Design Review Board Case # 20-0003
Blocks 4&5 – Carlyle Crossing Coordinated Sign Plan

Application	General Data	
Project Name: Carlyle Crossing Coordinated Sign Plan Special Use Permit Location: Blocks 4 & 5 – Eisenhower East 2410 and 2460 Mill Road Applicant: HTC 4/5 Project Owner LLC	DRB Date:	December 17, 2020
	Site Area:	5.07 acres
	Zone:	CDD #2
	Proposed Use:	Residential, Retail, Parking
	Gross Floor Area:	1,021,711 sf
Purpose of Application: DRB review and approval of a Coordinated Sign Plan for the Carlyle Crossing mixed-use project. The plan proposes a program of design guidelines, principles, and regulations for signage to include street- and upper-level retail signage, residential identity signage, and other site signage.		
Staff Reviewers: Robert M. Kerns, AICP robert.kerns@alexandriava.gov Thomas H. Canfield, AIA tom.canfield@alexandriava.gov Nathan Imm nathan.imm@alexandriava.gov Carson Lucarelli carson.lucarelli@alexandriava.gov Bill Cook william.cook@alexandriava.gov

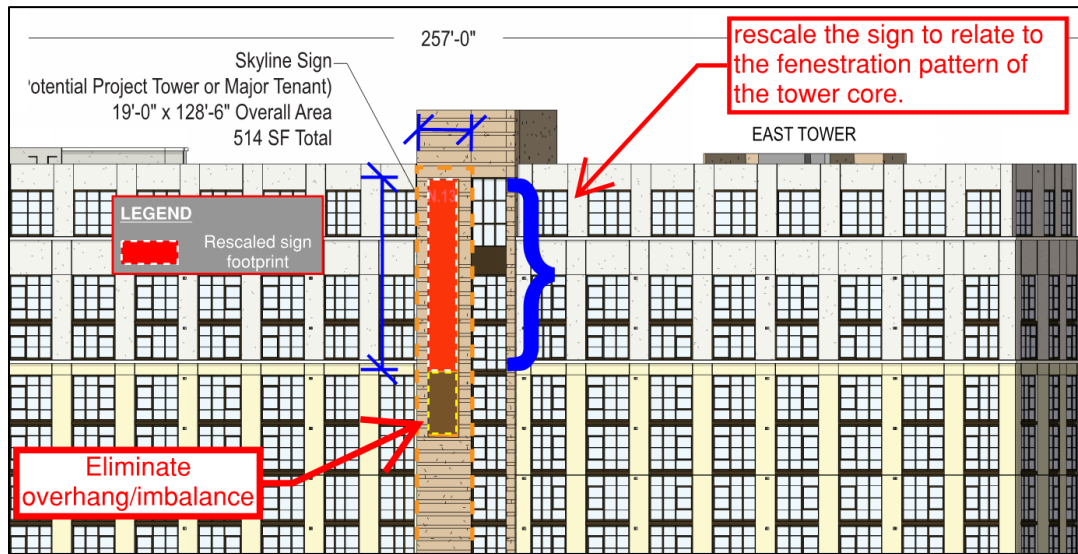
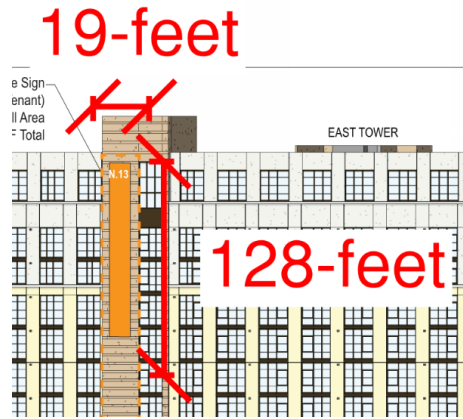
The requested signage is in generally agreeable locations between existing architectural elements and the proportions along the retail-base are reasonable. The garage and blade signage, which the DRB has previously seen, are also acceptably located and sized. Signage proposed at the retail level-3 are also in agreeable locations, however there is concern over the total volume of signage proposed above the maximum allowable height, which totals 6,784 square feet.

- ii. Level-3 Retail and Projecting Signage*
 The Applicant is proposing 6,784 square feet of signage above 35-feet, primarily at the third retail level, at a requested ratio of 2:1. This figure is inclusive of two projecting signs on Stovall Street totaling 1,070 square feet and is the reason for the aforementioned encroachment application. Staff find that the volume and requested ratios to be generally excessive and beyond the purpose and intent of the Sign Ordinance and Small Area Plan.

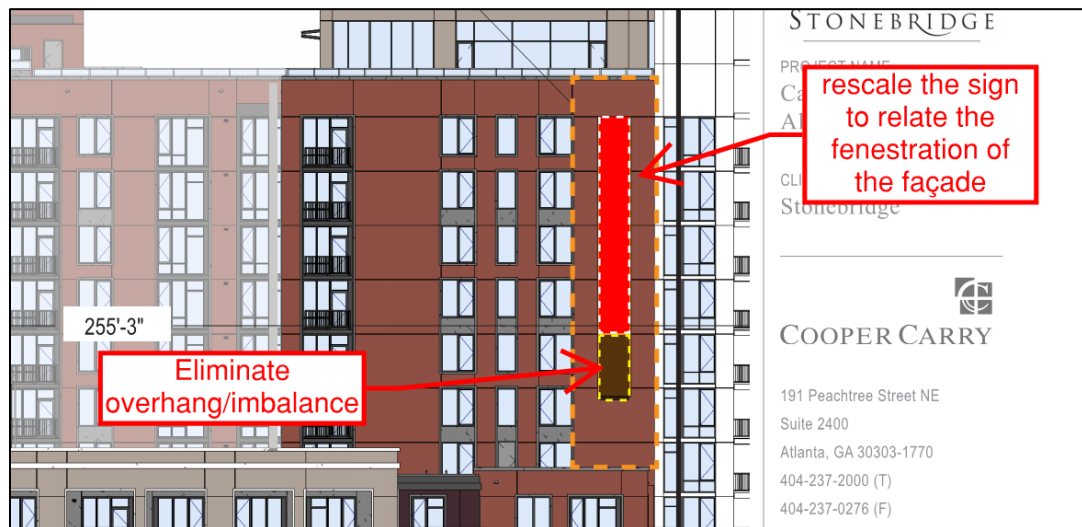
- i. Ground Level Signage*
 The Applicant proposes 1,577 square feet of retail, residential and parking garage related signage along the first-floor level, below 35-feet in height. The Applicant is requesting a ratio of 1.5 square feet per to 1 linear square feet of frontage, instead of the ordinance required 1:1. Given the size and scale of the development, Staff find that the signage proposed at these location to be generally acceptable. Blade signage is proposed at the pedestrian scale and is also found to appropriately located and sized.
